Economic Commission for Europe**Inland Transport Committee****World Forum for Harmonization of Vehicle Regulations****Working Party on Lighting and Light-Signalling****Seventy-third session**

Regulation No. 48 (Installation of lighting and light-signalling devices) –**Other proposals for amendments to Regulation No. 48****Proposal for the 07 series of amendments to Regulation
No. 48 (Installation of lighting and light-signalling devices)****Submitted by the experts from the International Organization of Motor
Vehicle Manufacturers (OICA) and the International Automotive
Lighting and Light Signalling Expert Group (GTB)***

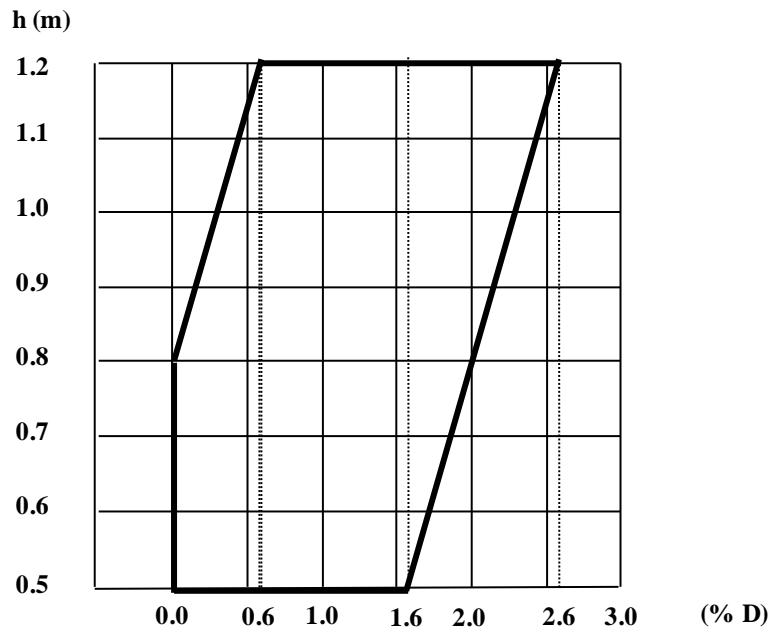
Insert new paragraphs 6.2.6.1.1. to 6.2.6.1.1.2., to read:

- "6.2.6.1.1. for vehicles in Category M₁ [and, at the discretion of the manufacturer, vehicles in category N₁ derived from M₁]

- 6.2.6.1.1.1. The initial downward inclination of the cut-off of the dipped-beam to be set in the unladen vehicle state with the addition of one person in the driver's seat shall be specified within an accuracy of 0.1 per cent by the manufacturer, and indicated in a clearly legible and indelible manner on each vehicle by the symbol shown in Annex 7 in a location close to either headlamp or the manufacturer's plate.

- 6.2.6.1.1.2. Depending on the mounting height in metres (h) of the [lower edge of the apparent surface in the direction of the reference axis of the dipped-beam headlamp], measured on the vehicles under the loading conditions prescribed in Annex 5 of this Regulation, the downward inclination of the cut-off of the dipped beam headlamp, starting from the initial inclination value set by the vehicle manufacturer as prescribed in paragraph 6.2.6.1.1.1. above, shall remain between the limits (see diagram below):

- h = 0.5 m: from 0.0 per cent to -1.6 per cent;
- h = 0.8 m: from 0.0 per cent to -2.0 per cent;
- h = 1.2 m: from -0.6 per cent to -2.6 per cent.

For the intermediate mounting heights, the limits vary linearly between the indicated values.

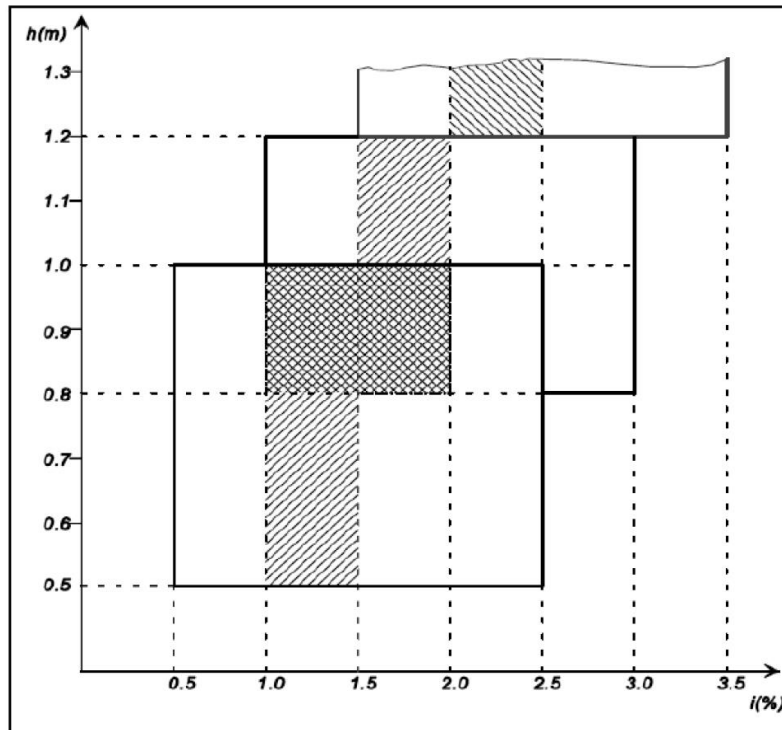
6.2.6.1.2.2. Depending on the mounting height in metres (h) of the lower edge of the apparent surface in the direction of the reference axis of the dipped-beam headlamp, measured on the unladen vehicles, the vertical inclination of the cut-off of the dipped-beam shall, under all the static conditions of Annex 5, remain between the following limits and the initial aiming shall have the following values:

$$h \leq 0.8$$

Limits: between -0.5 per cent and -2.5 per cent

Initial aiming: between -1.0 per cent and -1.5 per cent

Limits: between -1.0 per cent and -3.0 per cent

Initial aiming: between -1.5 per cent and -2.0 per cent

$h \geq 1.0$

Limits: between -1.0 per cent and -3.0 per cent

Initial aiming: between -1.5 per cent and -2.0 per cent

The above limits and the initial aiming values are summarised in the diagram below.

Figure No. 1

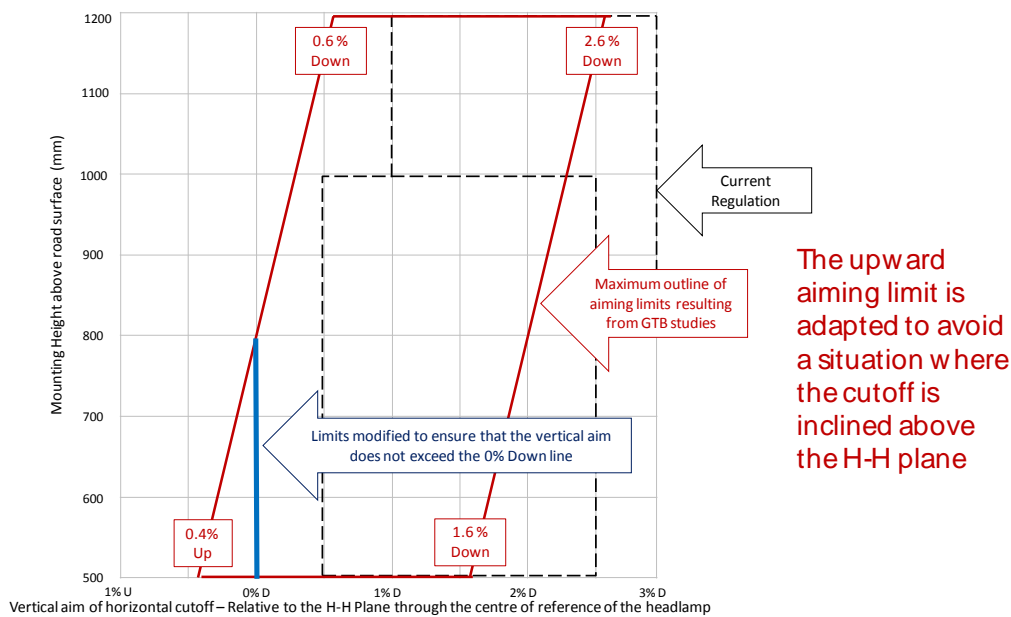
12. In addition to the question of glare, the expert from Poland emphasised the importance of maintaining adequate visibility distance. GTB concluded that it was necessary to extend the scope of its study to define an acceptable range of headlamp aim that would respect both glare and visibility concerns. Consequently, GTB decided to carry out a series of calculations following the CIE Standard S021/E: 2011 (GRE-71-32, pages 118-152).

13. The presentation of the work of the GTB CAVGS task force to the seventy-first session of GRE concluded with a diagram showing the absolute aiming limits, resulting from the CIE calculations, to respect glare and visibility considerations for a range of headlamp mounting heights. Discussion at the seventy-first session of GRE revealed concerns of the contracting parties related to the aiming of the cut-off above the H-H line (above 0 per cent D) in the case of the lower mounting heights. The diagram was amended to take account of these concerns as follows:

14. In conclusion, the joint GTB / OICA proposal is to introduce a criterion to determine in which cases automatic static headlamp levelling shall be installed. This criterion is based upon the pitch of the vehicle resulting from the 50 per cent load distribution shown below. This replaces the existing 2,000 lumen criterion and so introduces a performance-based requirement instead of the current design restrictive requirement.

Figure No. 2
50 per cent loading

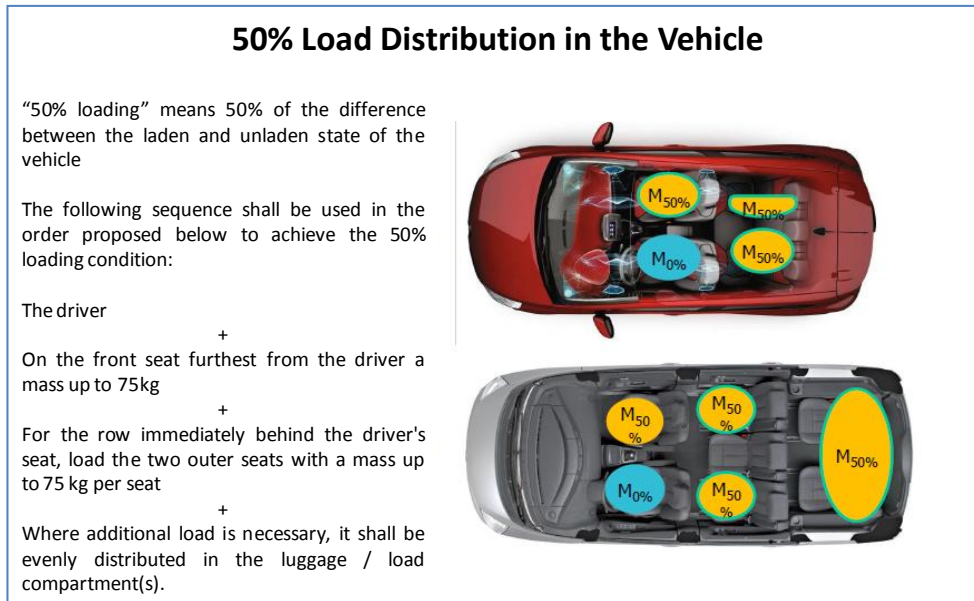
15. It is important to note that the "50 per cent loading" condition is in addition to the current loading conditions described in Annex 5 to Regulation No. 48.

Figure No. 3
Flowchart for levelling

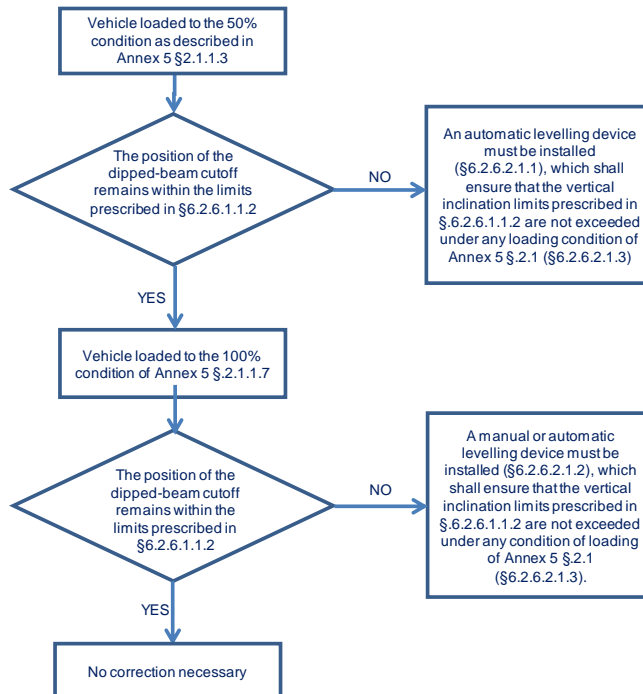
16. In the case where the application of the "50 per cent loading" criterion does not indicate mandatory automatic static headlamp levelling and the requirements of the "100 per cent loading" are not fulfilled, a manual or automatic levelling device shall be installed (please refer to the flow diagram below).
